REPORT TO TRANSPORTATION AND ROADS COMMITTEE

Date: 23 December 1992

ABERDEEN-INVERNESS TRUNK ROAD A96 KEITH BYPASS

SCOTTISH DEVELOPMENT DEPARTMENT
ABERDEEN - INVERNESS TRUNK ROAD (A96)
KEITH BYPASS

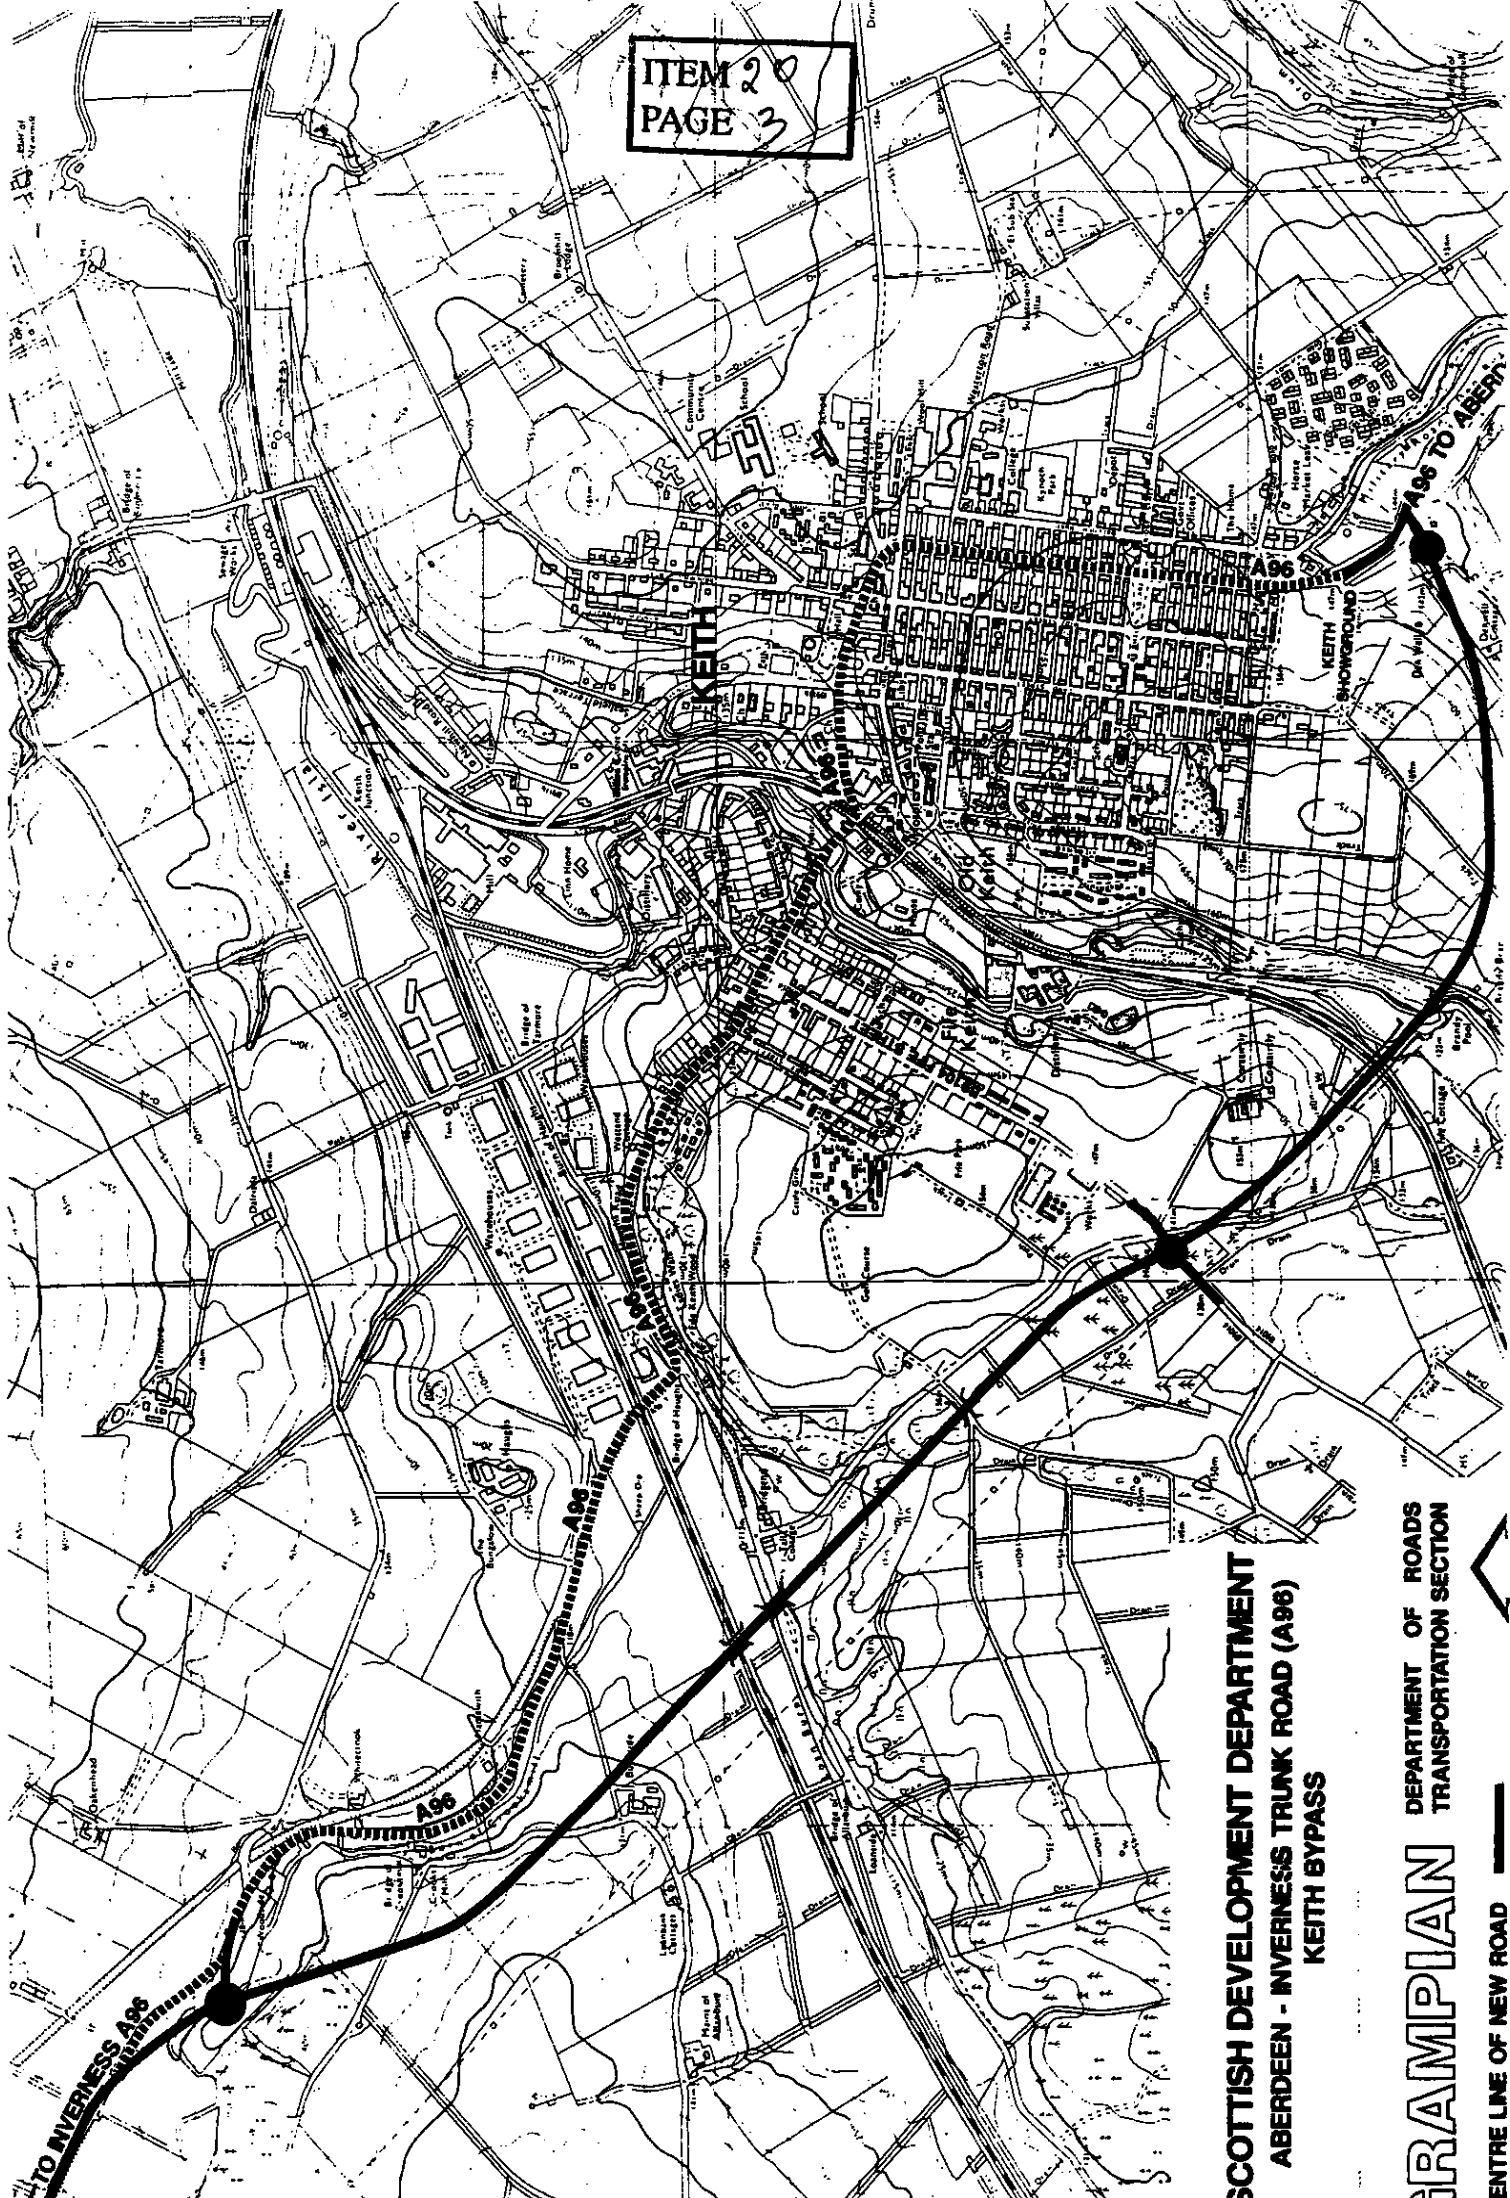
Proposed realignment of B9016 provides radius of 110m which is below absolute minimum standard for 30 mph and is not acceptable. It should be recommended that radius of 360 metres be provided to comply with absolute minimum radius for 50 mph.

2.5 At the south roundabout the U33H and U43H converge immediately prior to joining the roundabout and is unsatisfactory. The junction of the U43H with the U33H should take place on the straight before the roundabout.

**SCOTTISH DEVELOPMENT DEPARTMENT
ABERDEEN - INVERNESS TRUNK ROAD (A96)
KEITH BYPASS**

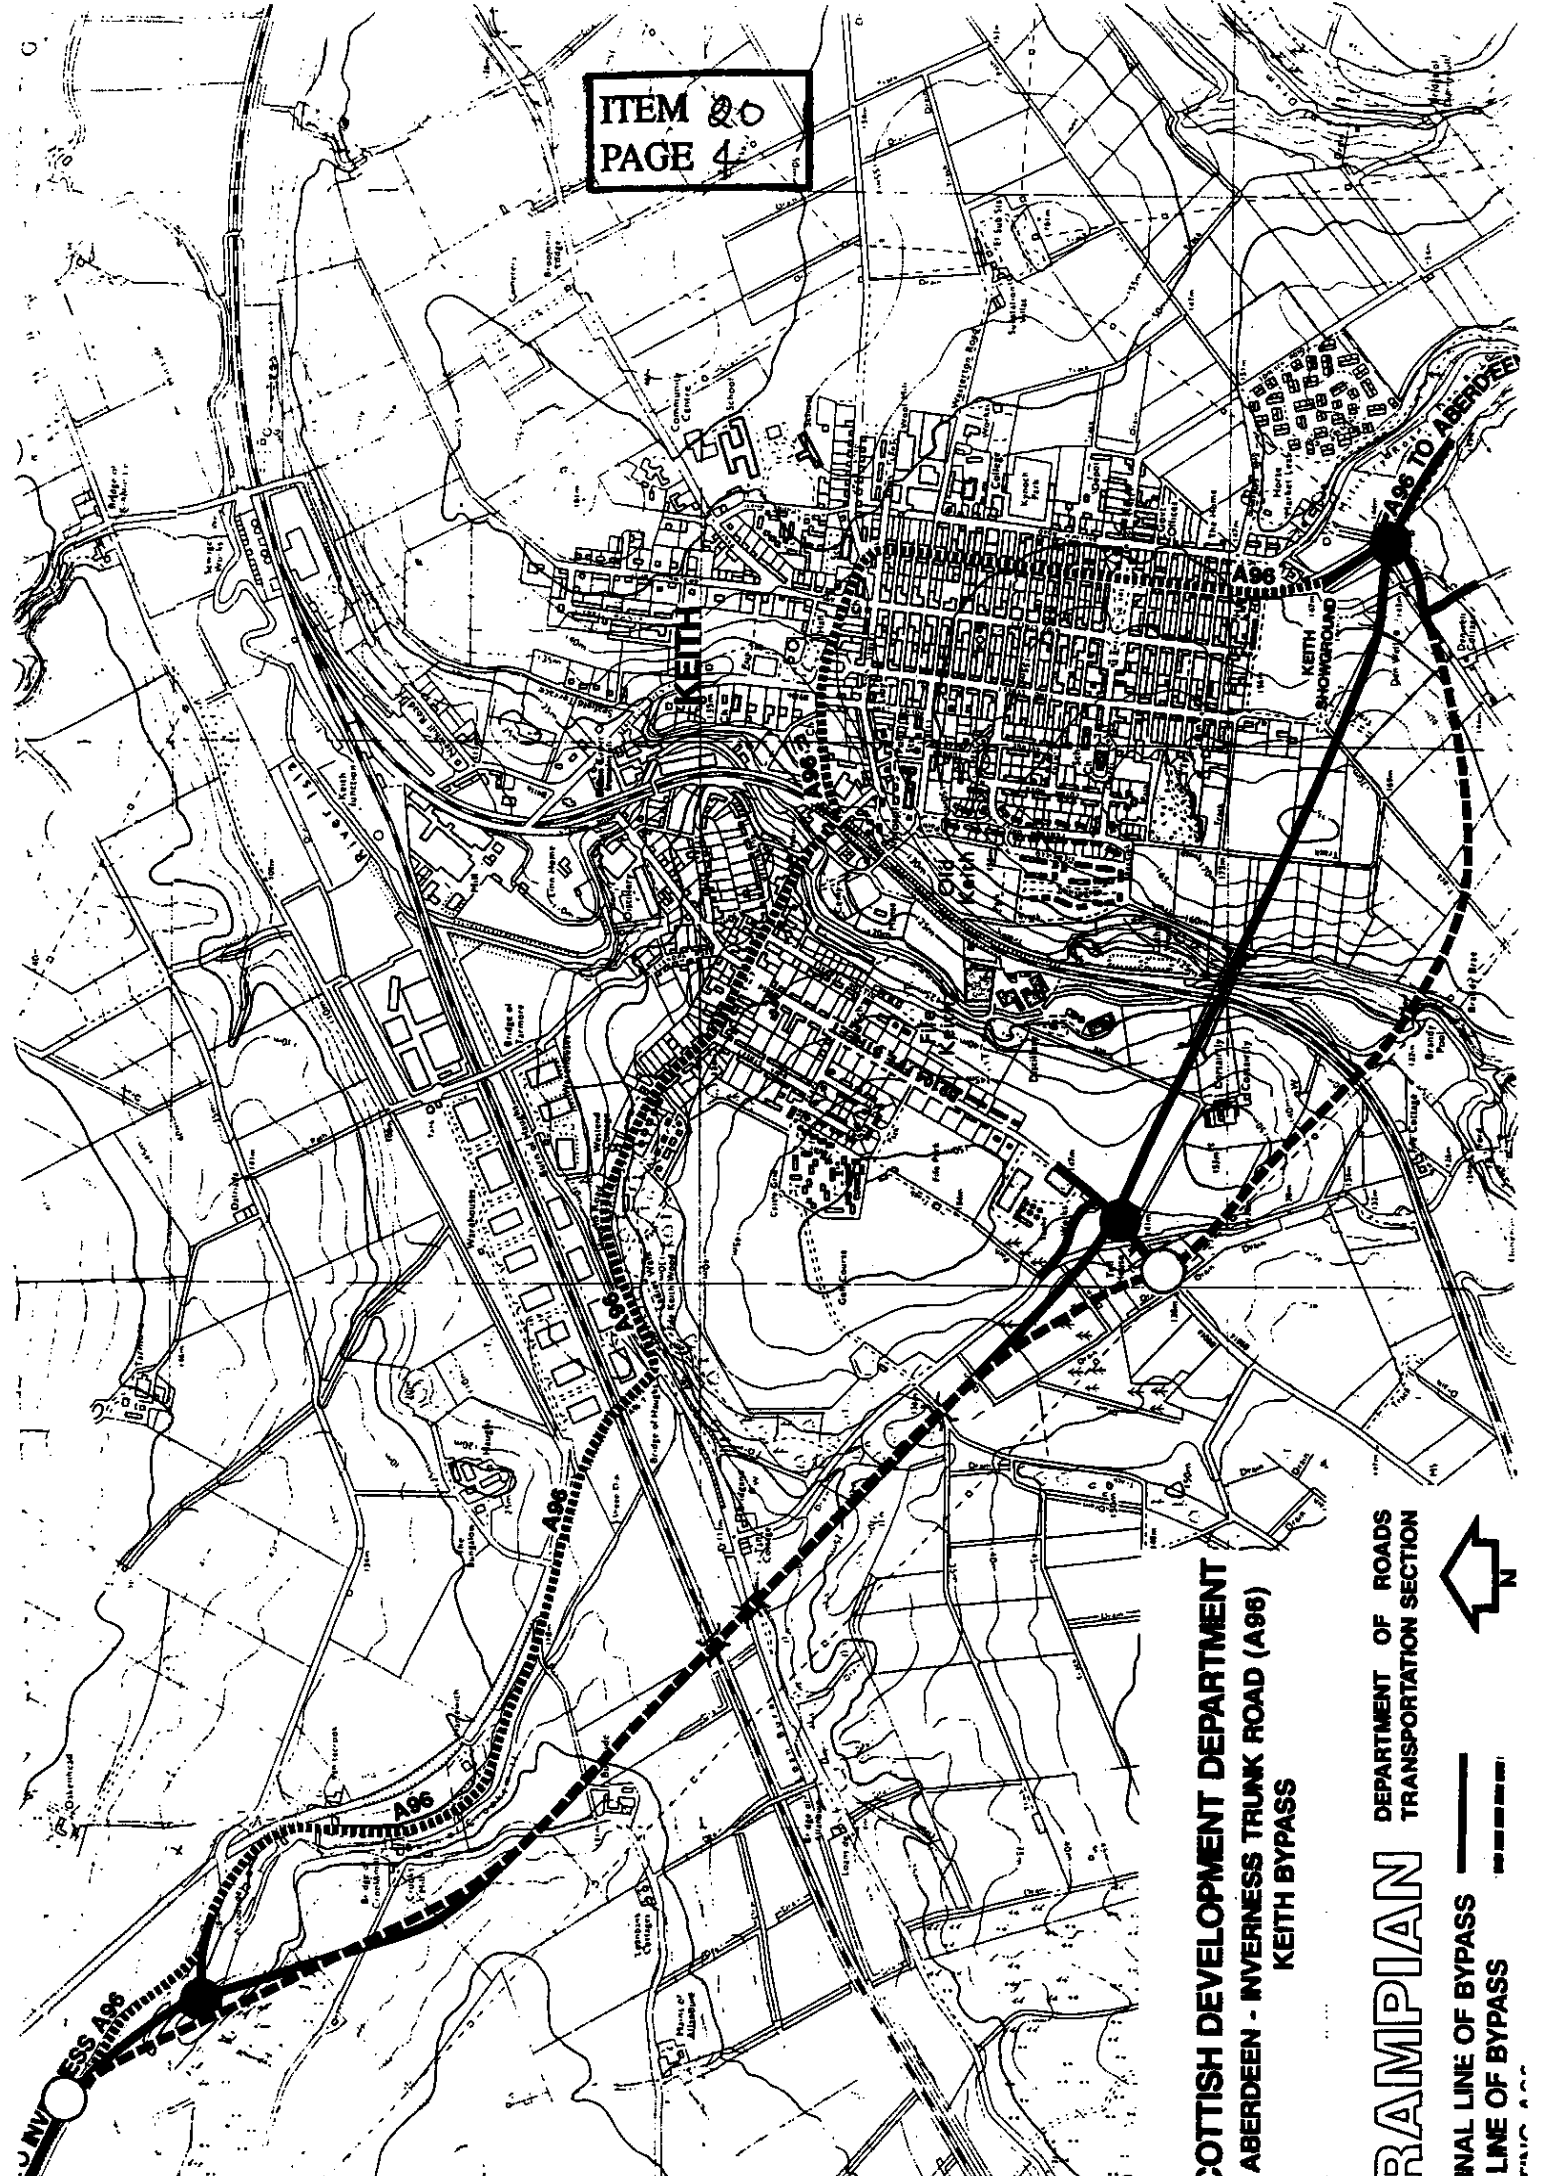
- 2.1 The main alterations to the draft Line Order previously published is that, from the same starting point on the A96(T) adjacent to the showground, the route swings further to the south of Keith. The effect of this is to keep the new road away from the showground which had been a matter of considerable concern when the previous draft Orders were published.
- 2.2 The line remains further south until a roundabout junction on the B9014. To the west of this junction it reverts to follow the previous line.
- 2.3 At the north-western end of the Bypass, a roundabout will be created near the existing junction of the B9016 which will be realigned to suit.
